STATE OF UTAH
DEPARTMENT OF NATURAL RESOURCES
DIVISION OF OIL, GAS AND MINING

APPLICATION FOR PERMIT TO DRILL		5. MINERAL LEASE NO: ML-21329	6. SURFACE: State
1A. TYPE OF WORK: DRILL <input checked="" type="checkbox"/> REENTER <input type="checkbox"/> DEEPEN <input type="checkbox"/>		7. IF INDIAN, ALLOTTEE OR TRIBE NAME:

2. NAME OF OPERATOR: KERR MCGEE OIL & GAS ONSHORE L.P.		9. WELL NAME and NUMBER: NBU 1021-28E	
3. ADDRESS OF OPERATOR: 1368 S 1200 E CITY VERNAL STATE UT ZIP 84078		PHONE NUMBER: (435) 781-7024	10. FIELD AND POOL, OR WILDCAT: NATURAL BUTTES

NBU 1021-28E
SW/NW SEC. 28, T10S, R21E
UINTAH COUNTY, UTAH
ML-21329

APPROXIMATE TOTAL 8" PIPELINE DISTANCE = 12,100' +/-

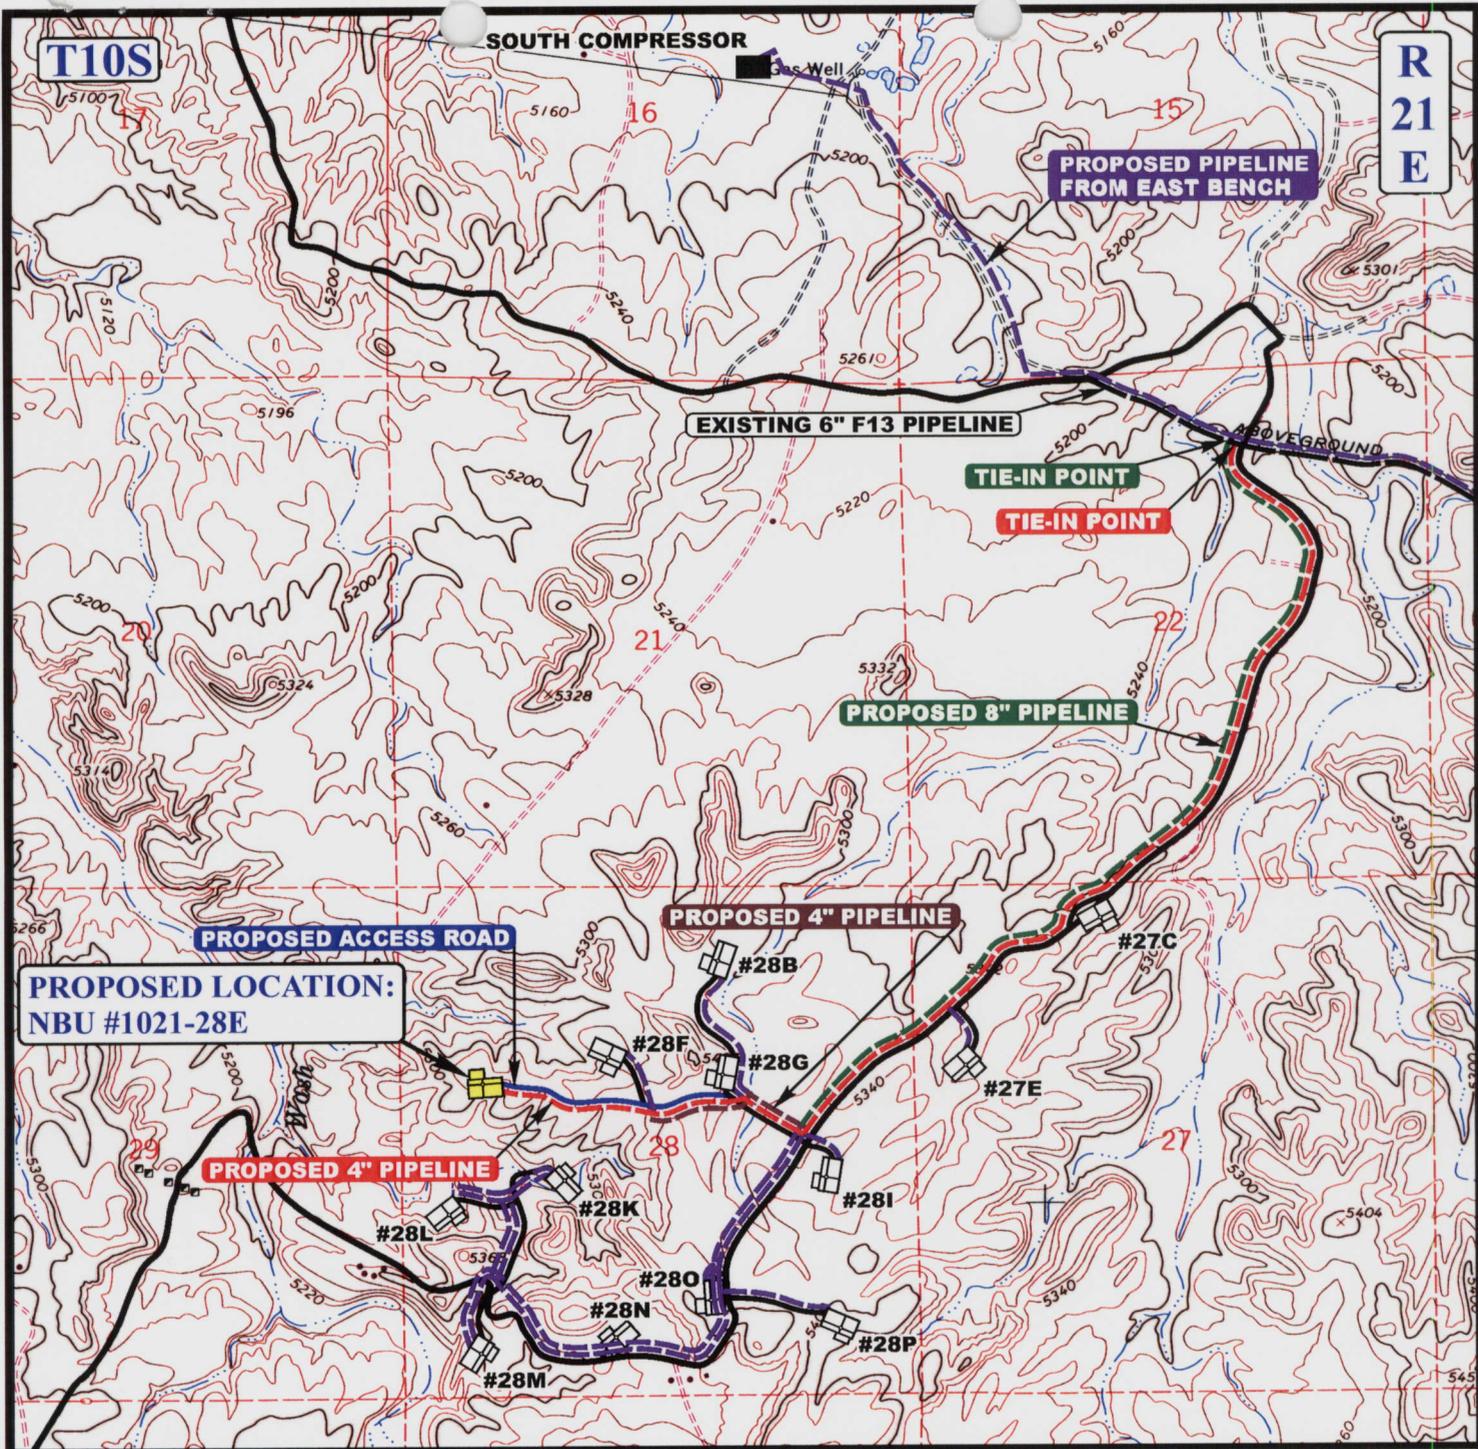
An onsite was conducted on 4/5/07 with the Division of Oil, Gas and Mining Representative and SITLA Representative. It was decided to change the proposed pipeline from a 4" pipeline that was approximately 2,493' +/- to, two 4" pipelines approximately 15,400' +/-, and 1,900' +/-, and an 8" pipeline approximately 12,100' +/- . These pipelines also cross onto Federal lands in Sec 27 and tie into a point in Sec 22 of T10S-R21E.

APPROXIMATE TOTAL 8" PIPELINE DISTANCE = 8,750' +/-

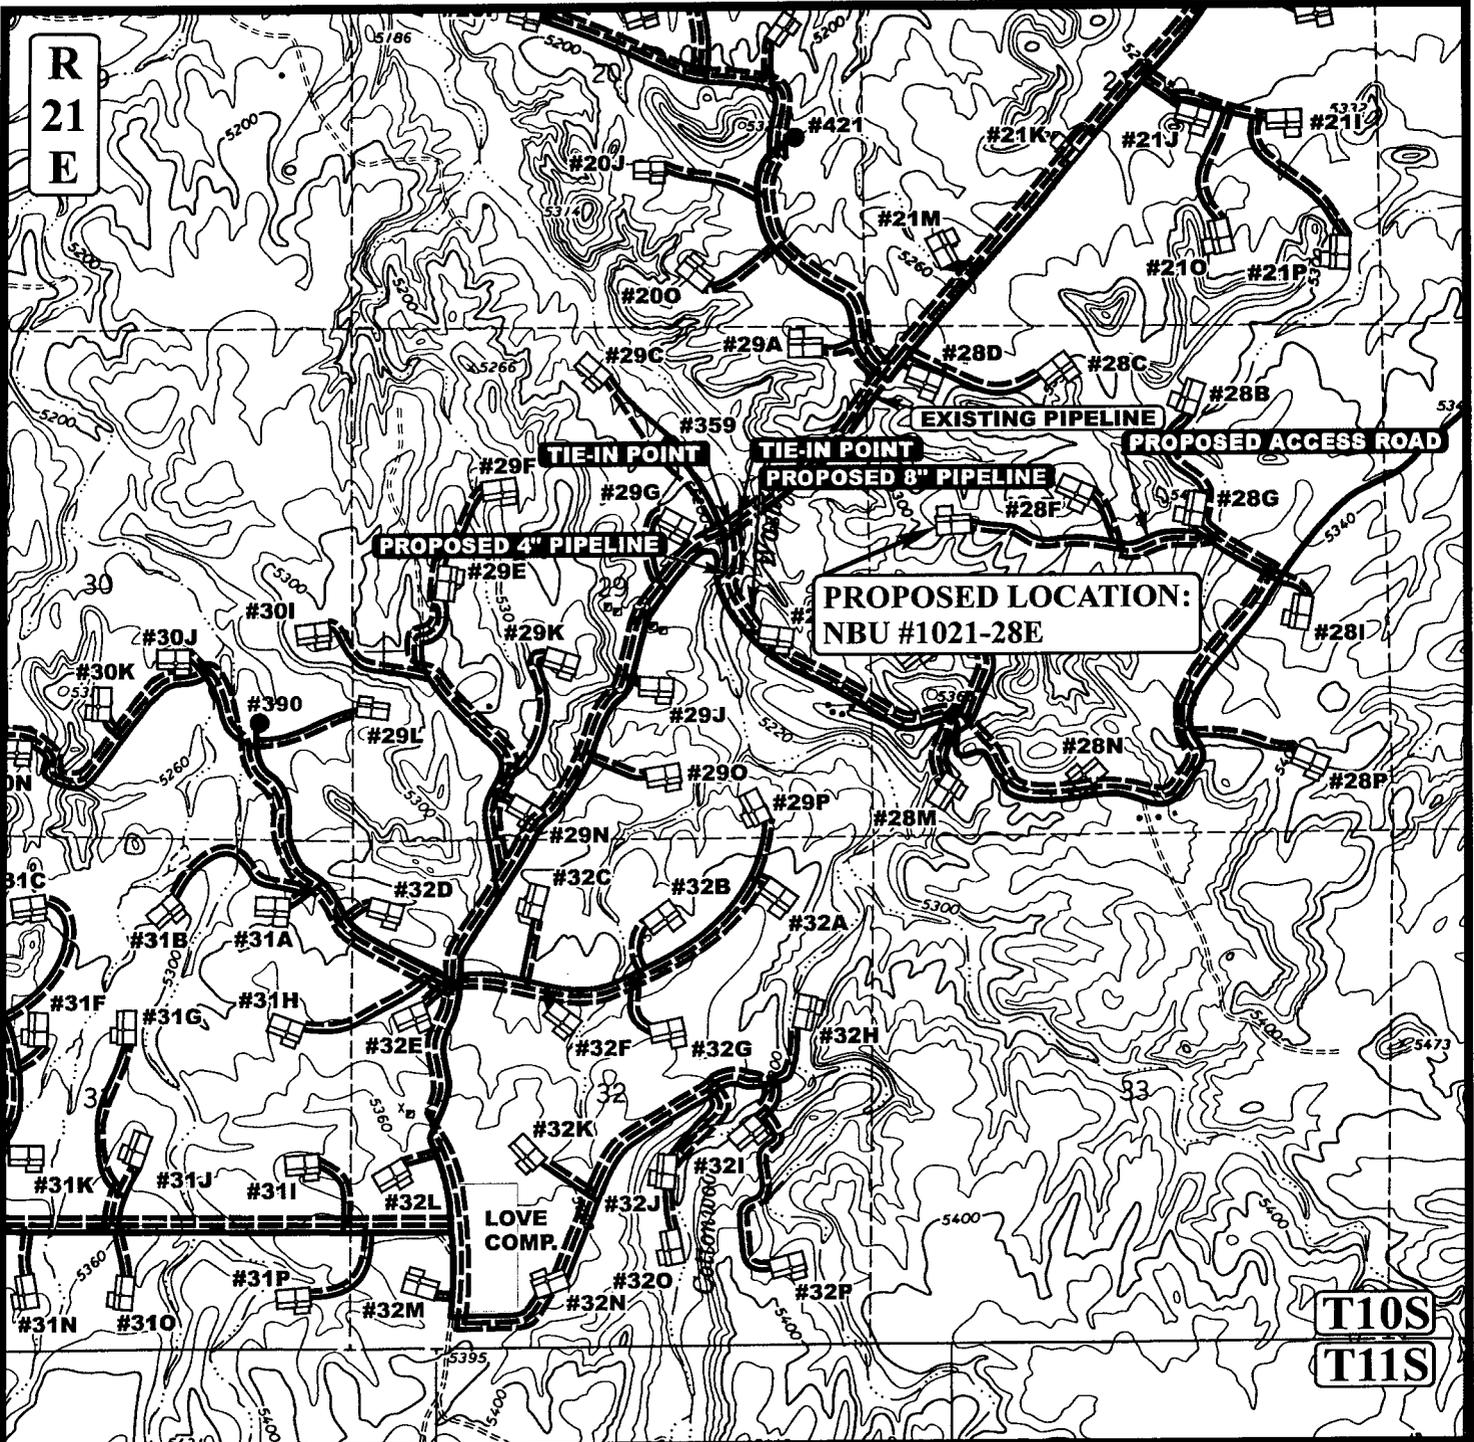
An onsite was conducted on 4/5/07 with the Division of Oil, Gas and Mining Representative and SITLA Representative. It was decided to change the proposed pipeline from two 4" pipelines approximately 15,400' +/-, and 1,900' +/-, and an 8" pipeline approximately 12,100' +/- to two 4" pipelines approximately 12,200' +/- and 8,750' +/- and an 8" pipeline approximately 8,750' +/-.

Please replace the sundry dated 4/18/07 with this sundry dated 5/8/07.
